Appendix A Design Update 01, February 2025

Design Update Request/Notification

FORM A – SUMMARY OF REQUEST/NOTIFICATION			
Project:	The Medworth Energy from Waste Combined Heat and Power Facility Order 2024 Made: 20 February 2024		
Reference:	CP3_R2_DU01		
Originator:	Medworth CHP Limited (the Developer)		
Name:	Tim Marks	Position:	Head of Planning
Issued to:	Cambridgeshire County Council	Date issued:	05/12/2024

EfW CHP Facility Design Update 01

Graphic 2.1: East elevation of the EfW CHP Facility building and structures

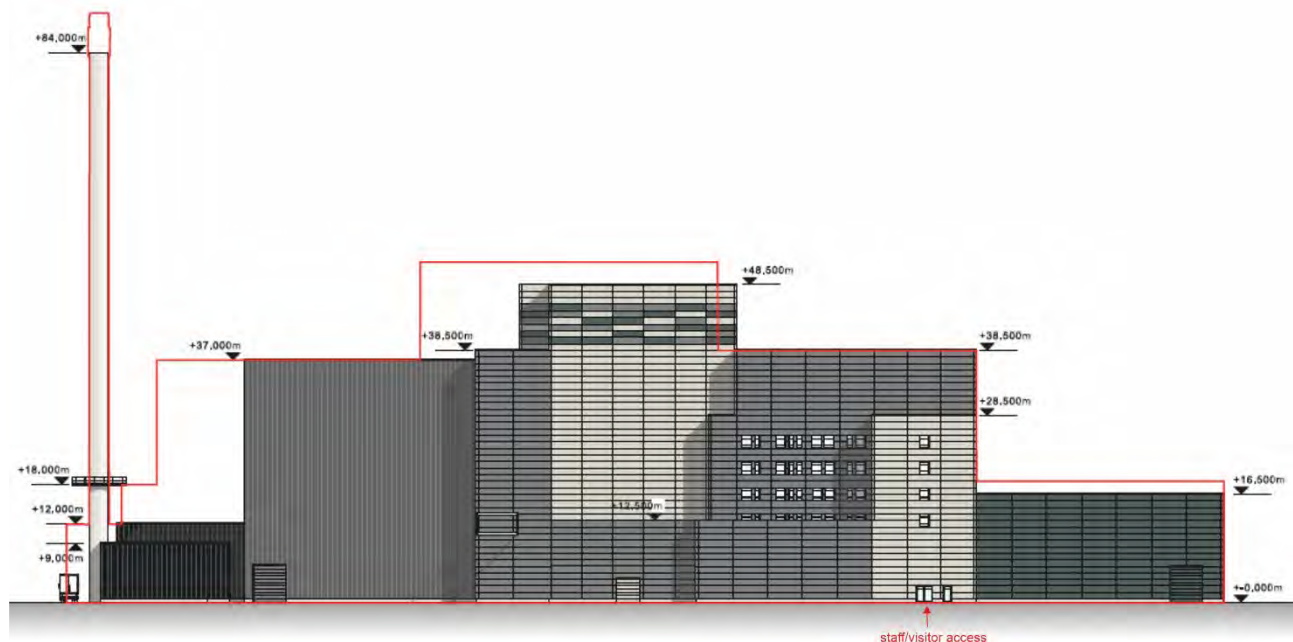
- 2.1.3 The DU01 proposals include a reduction in height of the waste reception building, boiler house, turbine building, ACC³ and chimneys and a reduction in volume of the boiler house and APC building, turbine building and ACC. Whilst there is some horizontal movement of the position of the boiler house, APC building and ID fans, these are within the horizontal limits of deviation, see **Section 2.2**.

Graphic 2.5: Work No.1 horizontal limits of deviation

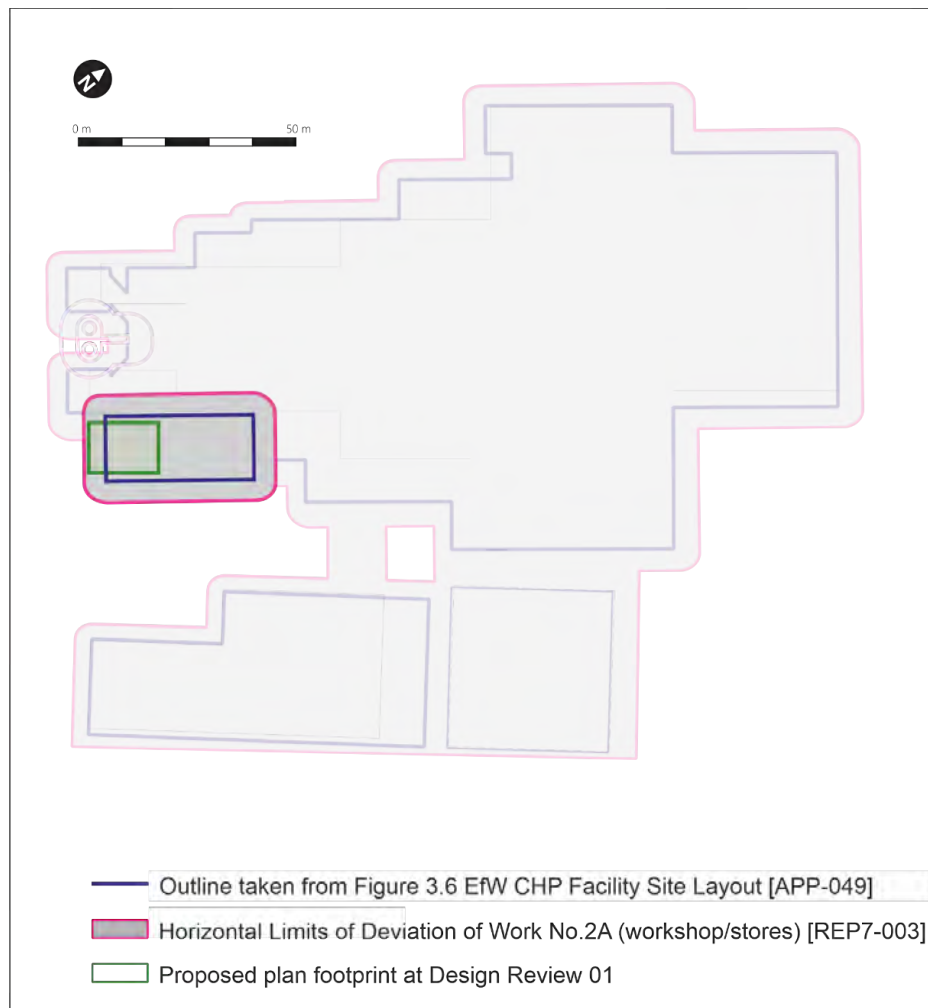
A reduction in the footprint has led to a revised position, however, all buildings and structures within Work No.1 remain within the horizontal limits of deviation as identified in the Works Plans.

Graphic 2.6: Work No.2A (Workshop/stores only) horizontal limits of deviation

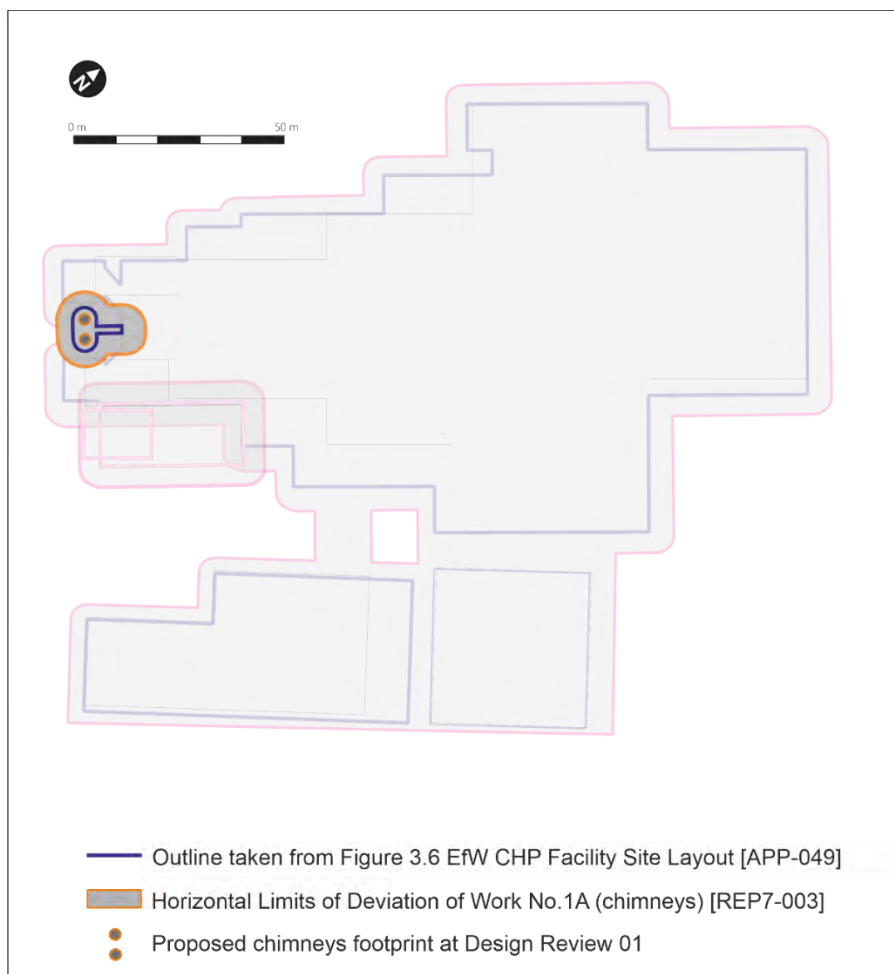
A reduction in the footprint has led to a revised position, however, the workshop/stores building (Work No.2A) remains within the horizontal limits of deviation as identified in the Works Plans.

Figure 3.7ii
EfW CHP Facility Elevations

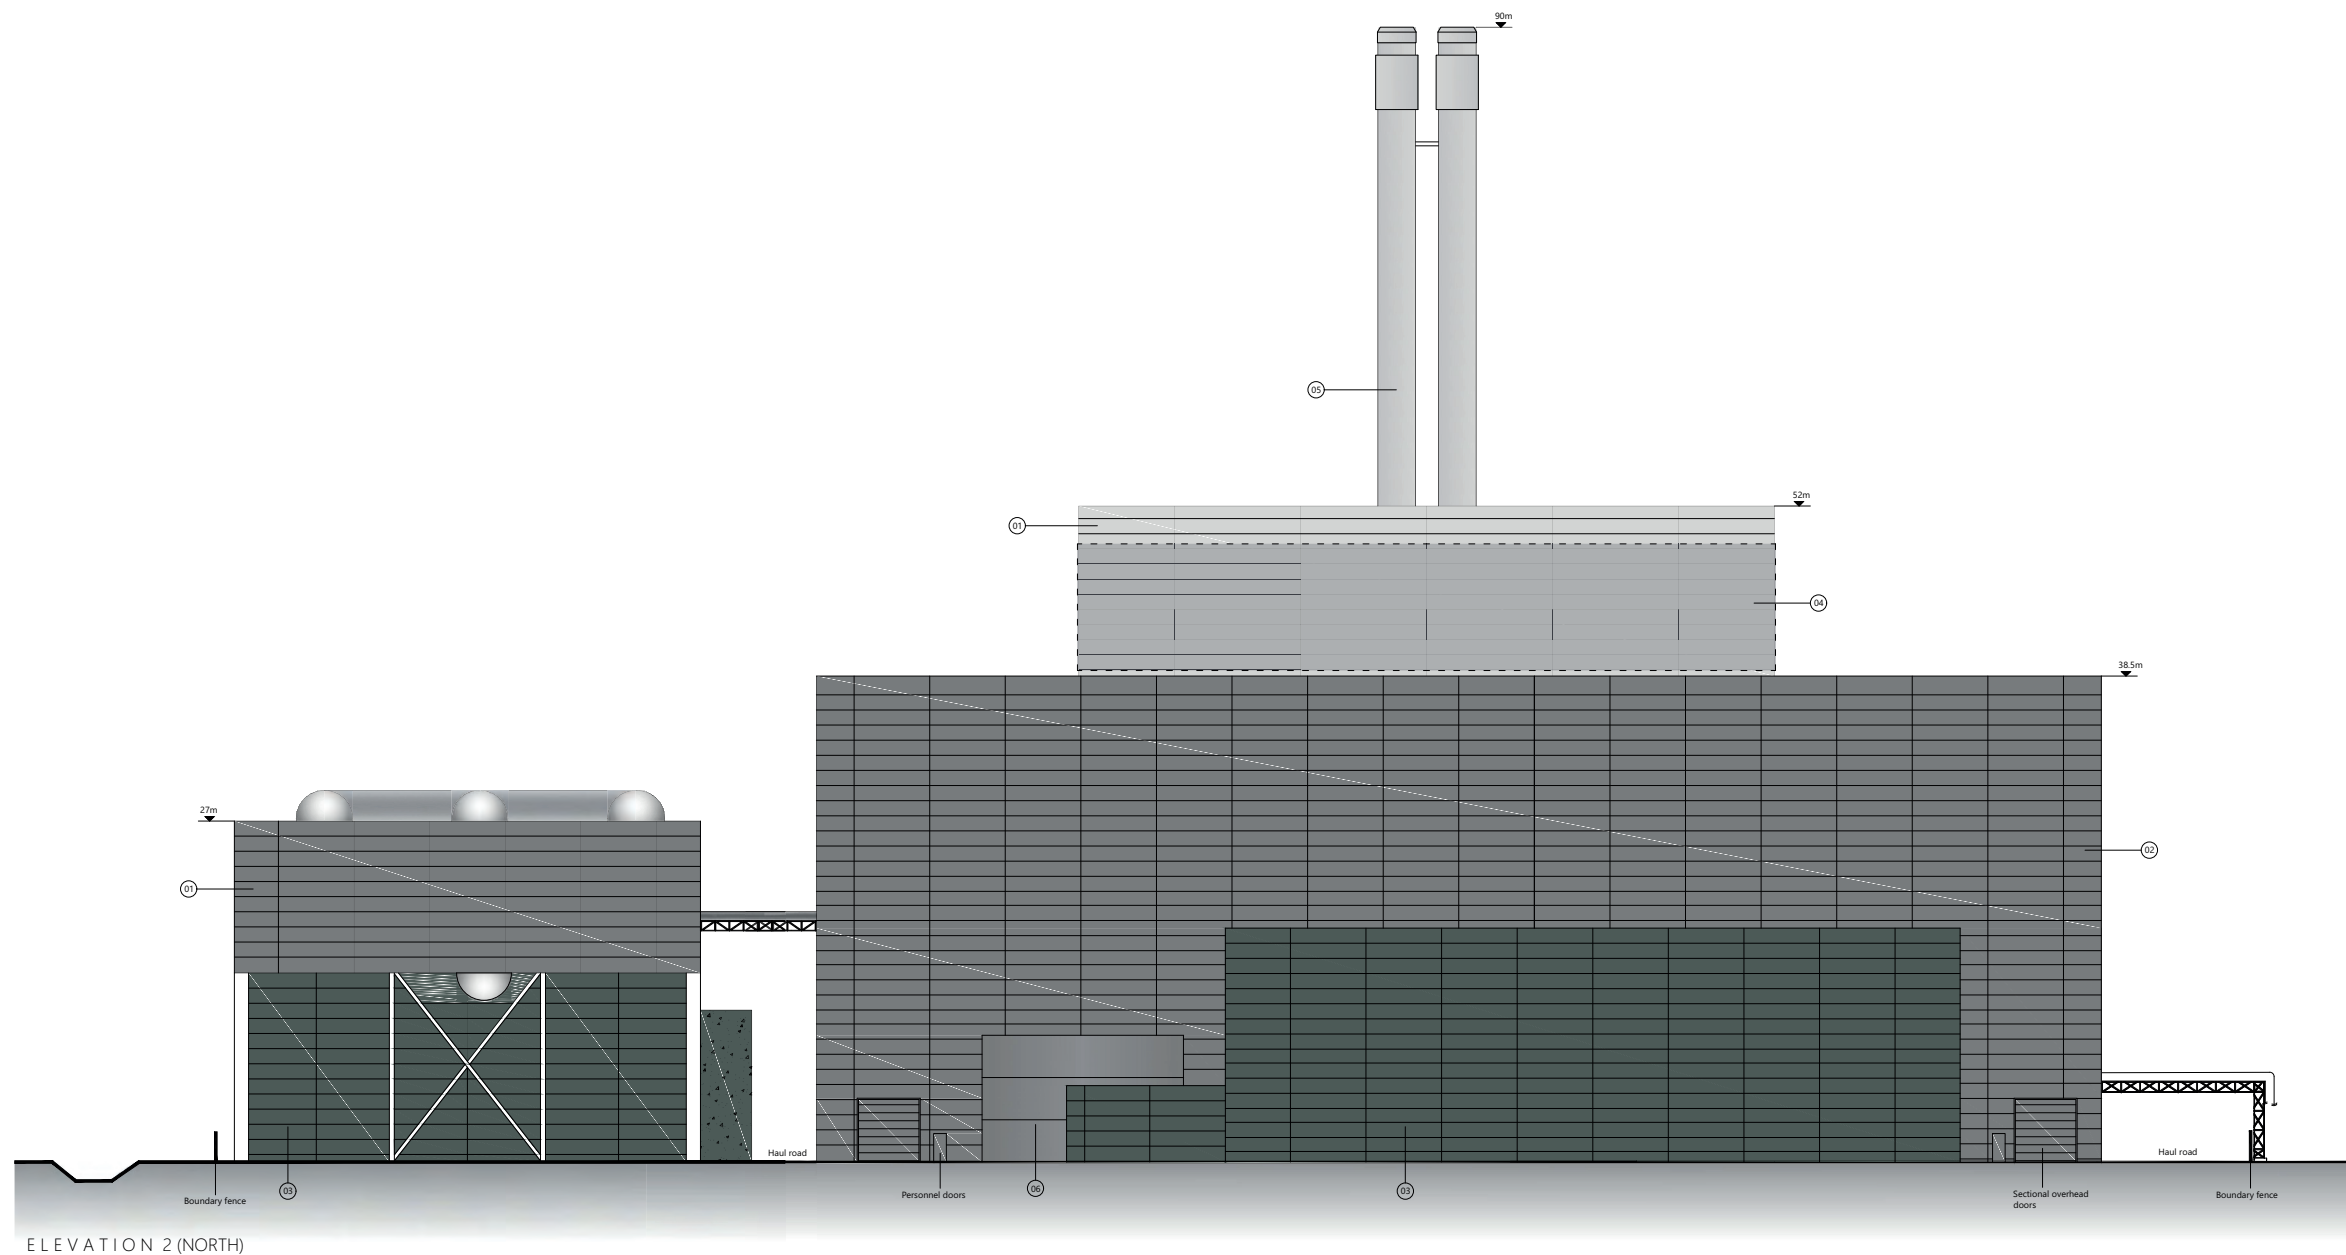
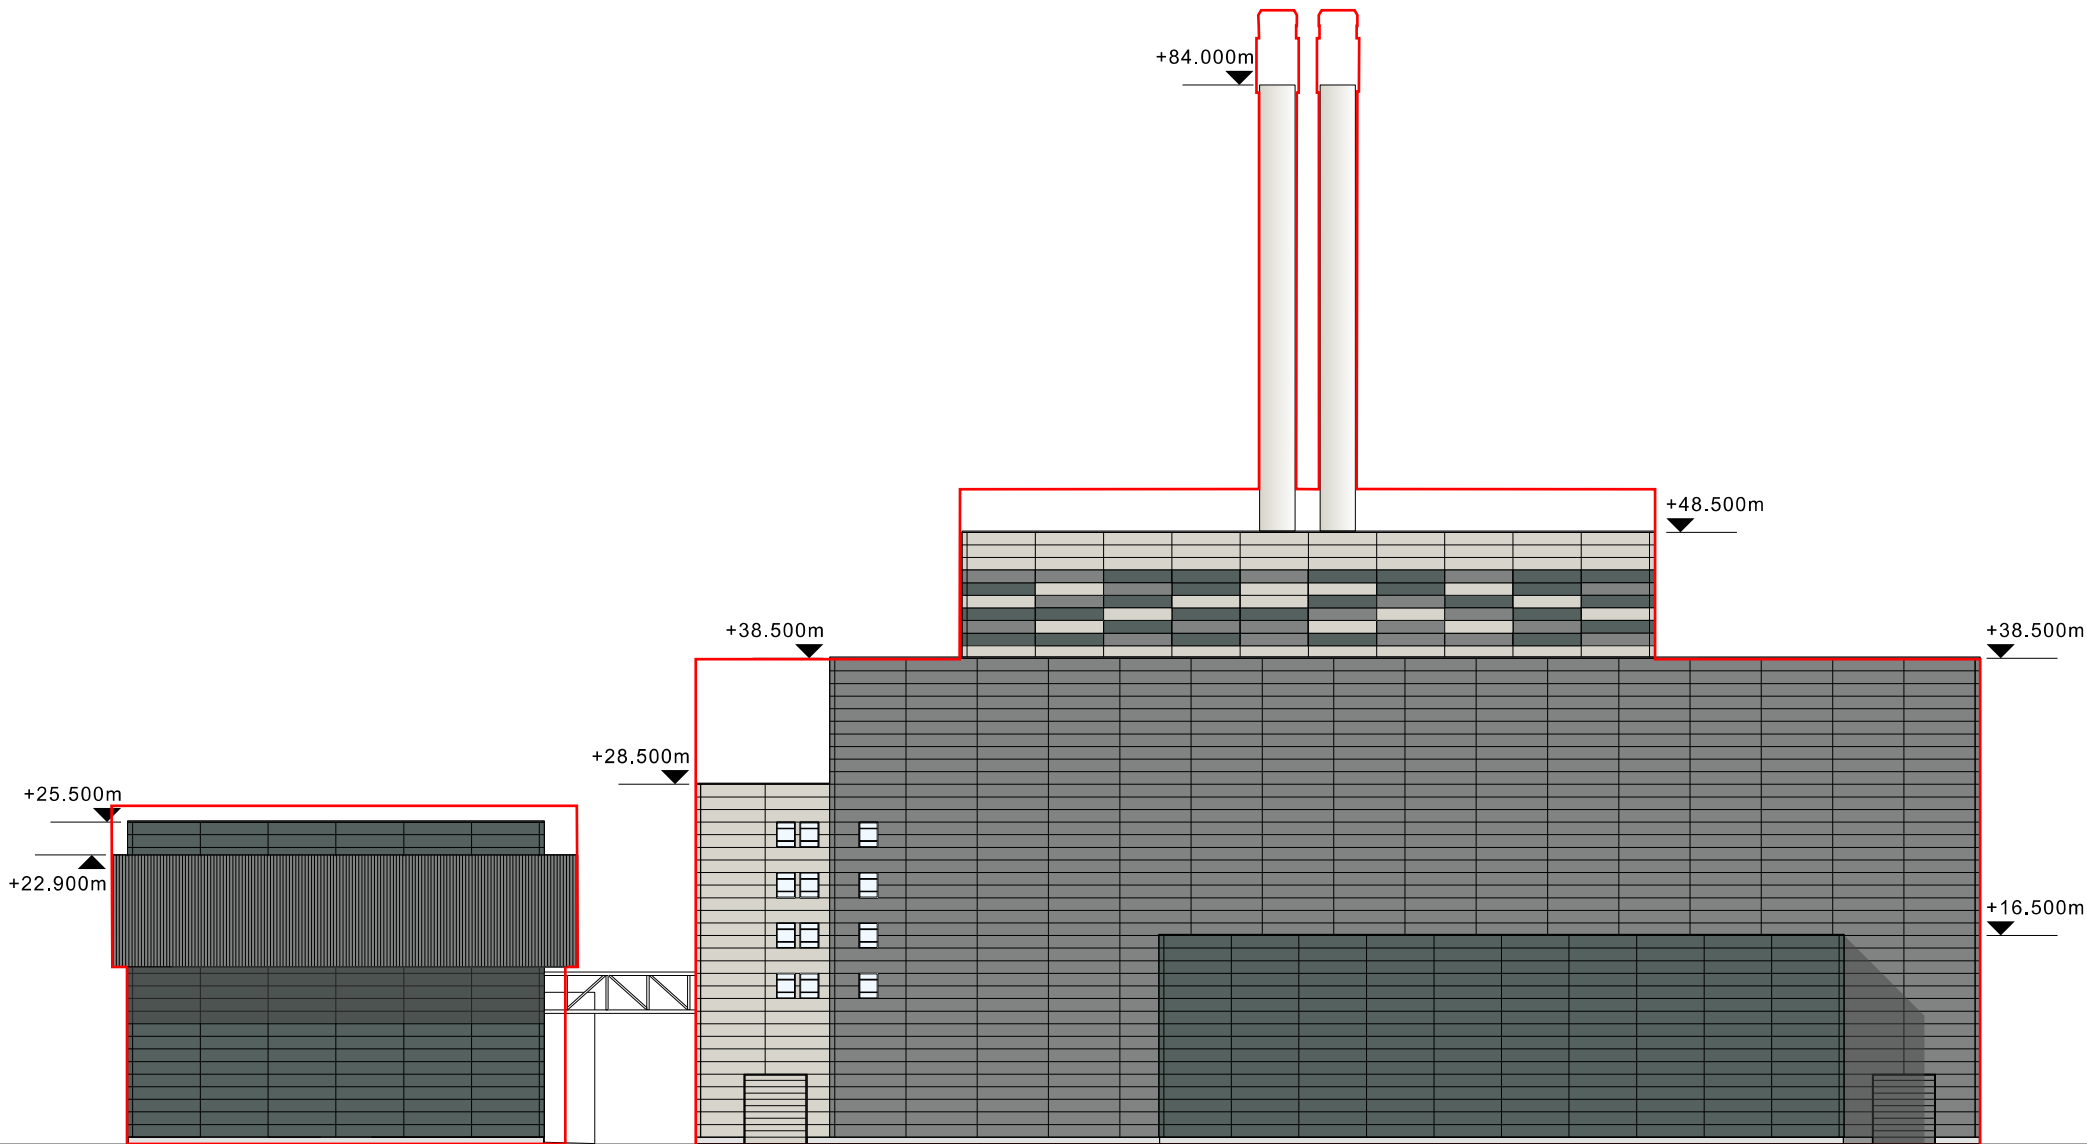
— Outline taken from 3.7_i-iv-3.8-EfW-CHP-FacilityElevations (North Elevation)
